**PUBLIC UTILITY COMMISSION OF OREGON
STAFF REPORT
SPECIAL PUBLIC MEETING DATE: July 30, 2024**

SUBJECT: IDAHO POWER:
(Docket No. LC 84)
Acknowledgement of the 2023 Integrated Resource Plan.

STAFF RECOMMENDATION:

Figure 1: Comparison of Portfolio Costs (in thousands)

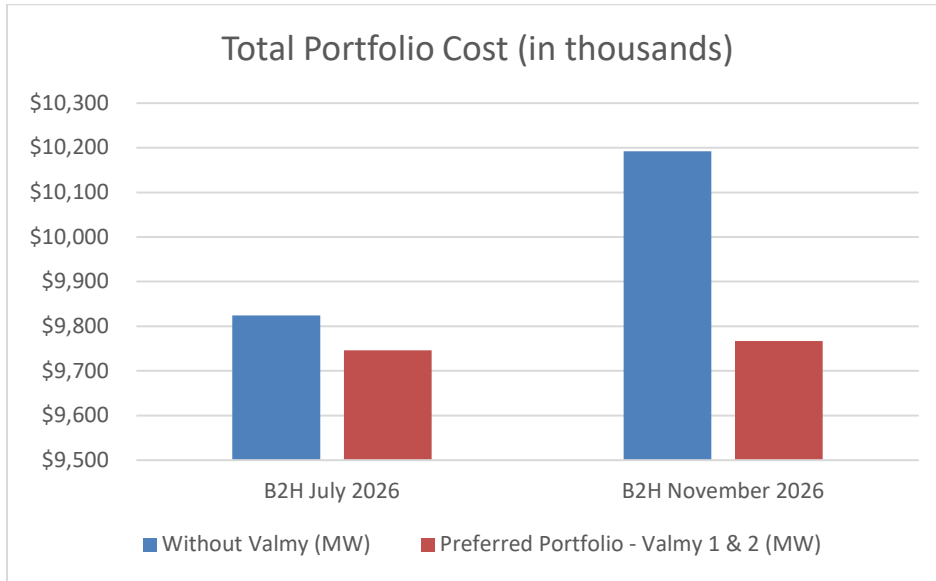
Figure 1 shows the comparison of portfolio costs for the "With Valmy 1 and 2" and "Without Valmy" for both the B2H online in July 2026 and B2H online in November 2026. Allowing the model to select the Valmy conversions provides more than five times the savings in the delayed B2H in-service date of November 2026, as compared to the originally planned B2H in-service date in July 2026. The Company claims that the high savings in portfolio cost of \$425M is a reflection of how Idaho Power's relies on the Valmy conversions to help mitigate the risk of an anticipated delayed B2H in-service date beyond July 2026.¹⁹

Staff prefers to use the B2H November 2026 online case to investigate the drivers for the cost difference from the “Valmy 1 and 2” portfolio, as shown in Figure 2, and the “Without Valmy” portfolio, as shown in Figure 3. Staff chose the case of B2H online in November 2026, as the B2H online in July 2026 is no longer possible.

Figure 4: Composition of System Company Electricity Sales (thousands of MWh)⁴⁶

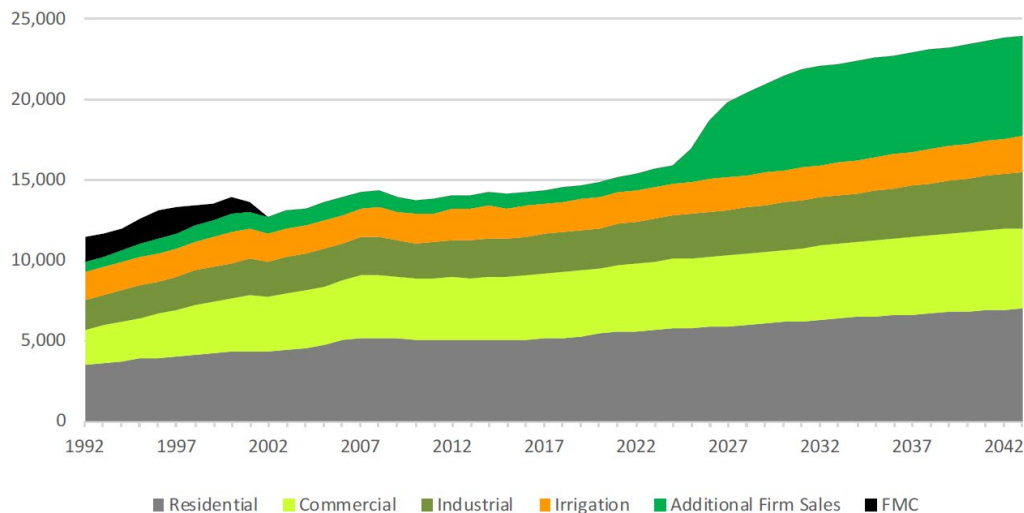
However, the near-term annual average load growth between 2024 and 2028 is especially steep at 5.5 percent and is heavily weighted by additional firm sales to ESA customers, as shown in Figure 4.⁴⁵

Figure 5: IRP Representation of ESA Customer Energy Load in MWh

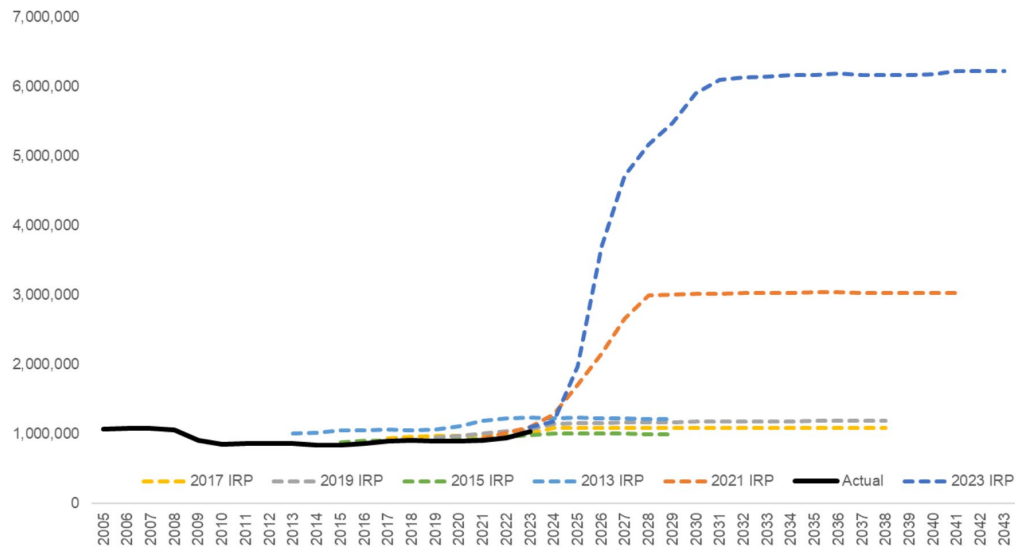
In Comments, Staff noted that the accuracy of Idaho Power’s forecast of system load may become compromised if the near-term growth of ESA load does not materialize. Idaho Power is ultimately responsible for the reasonableness of these ESA customers’ load forecast and should be prepared to provide oversight to avoid the over-procurement of resources. Figure 5 shows the difference in ESA customer load forecasts across IPC’s past IRPs.

Staff agrees that the Idaho Power system is experiencing growth and is supportive of the Company taking the necessary steps to meet these needs. However, Staff notes that this new growth introduces uncertainty regarding timing and volume of need. Given that the Company is currently developing its 2028 RFP (Docket No. UM 2317), Staff plans to address this issue in the RFP design and associated sensitivities.
